APPROVED
Limited building only review
Permit holder responsible for
full compliance with the code

10' X 12' ORGANIZER
5/12 PITCH W/LEAN-TO

Re: Structural Certification
10', 12', & 16' Organizer Sheds

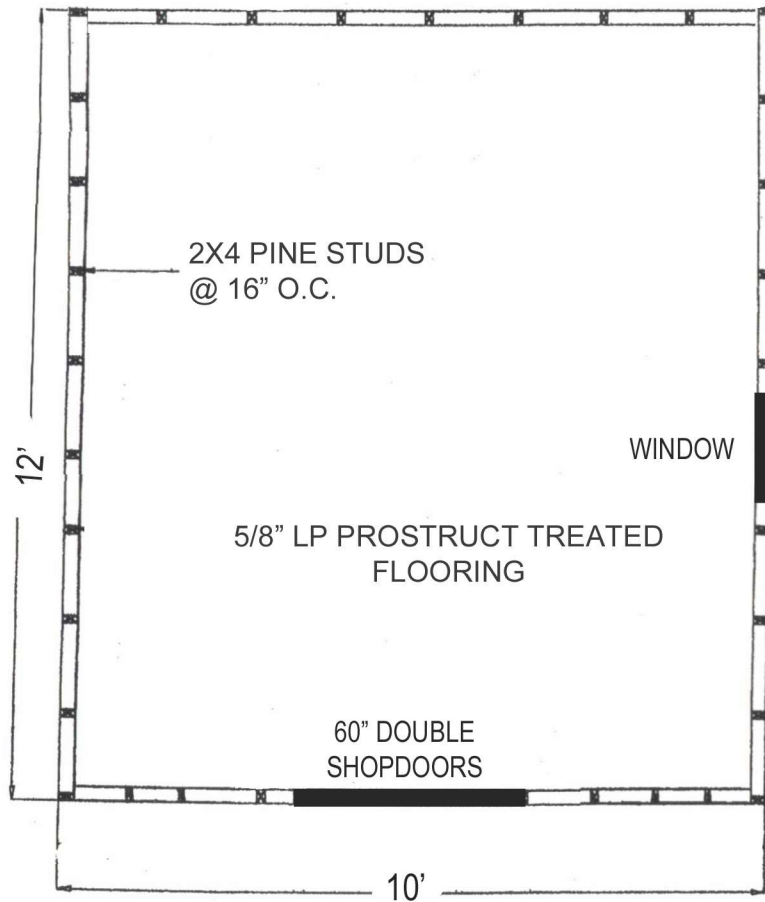
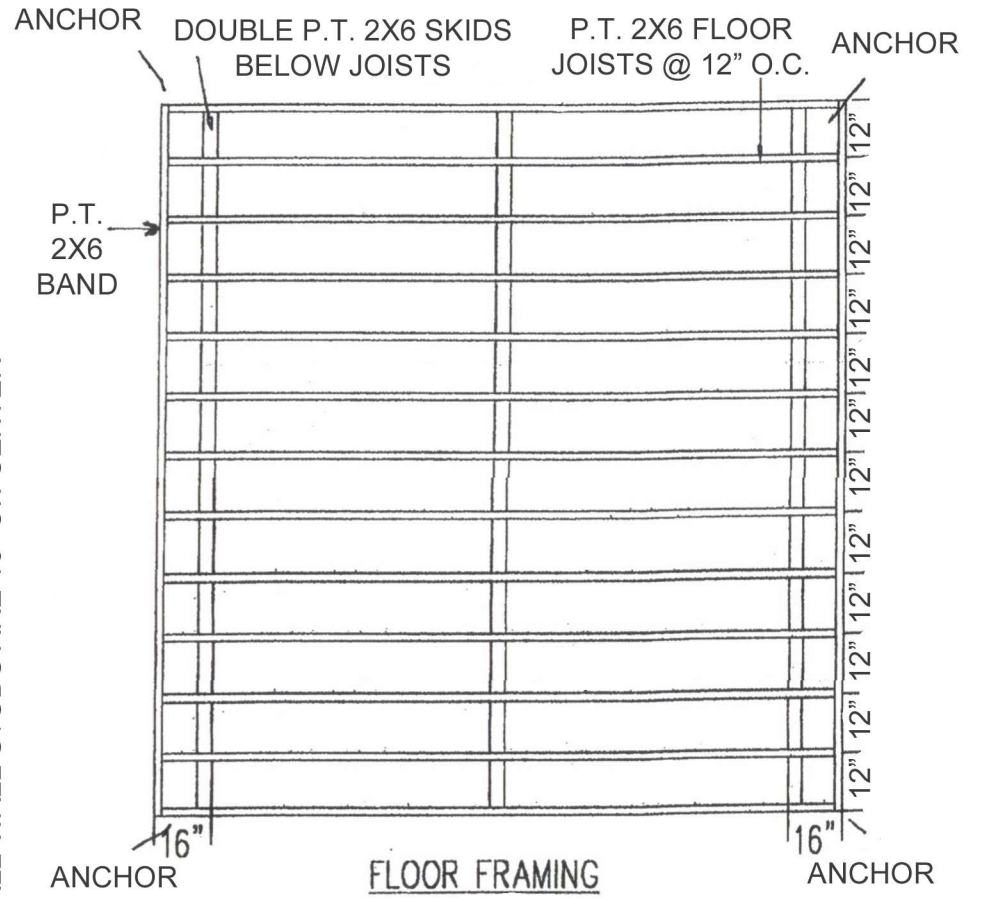
This variation consists of a 10' wide shed with a gable roof system. The roof consists of 2x4 rafters @ 2'-0" on center at either a 5:12 or 9:12 pitch, and the walls are constructed with 2x4 studs at 16" on center. **Please be advised that the rafters shall be cross-tied with 2x4 collar ties located at the 1/3 point extending downward from the ridge and spaced at 4'-0" on center. The collar ties should be attached at each rafter with a minimum of (6) 10d nails**

The floor framing consists of 2x4 joists at 16" on center supported on three (3) 4x4 "skids". Please be advised that the 2x4 floor joists can have a maximum of 10 1/2" cantilever beyond the 4x4 supports. Furthermore, please be advised that the 4x4 skids must be intermediately supported by piers at a maximum of 4' on center. Alternatively, if a double 2x6 beam is used for the skids, they must be supported at a maximum of 5' on center. The skids may bear on 8"x16" CMU piers which bear directly on the soil. The piers may be constructed with dry stacked concrete masonry units, with solid units top and bottom and hollow 8" concrete masonry units for the remainder of the pier at a maximum height of 36". The floor framing should be tied down with 30" screw anchors and 1" metal strapping across the floor joists.

Wood stud headers over openings not exceeding 6'-0" in the end walls (non-load bearing) shall be (2) 2x4 studs bearing on a single 2x4 jack stud at each end. Headers over openings not exceeding 6'-0" in the side walls (load bearing) shall be (2) 2x6 studs bearing on double 2x4 jack studs.
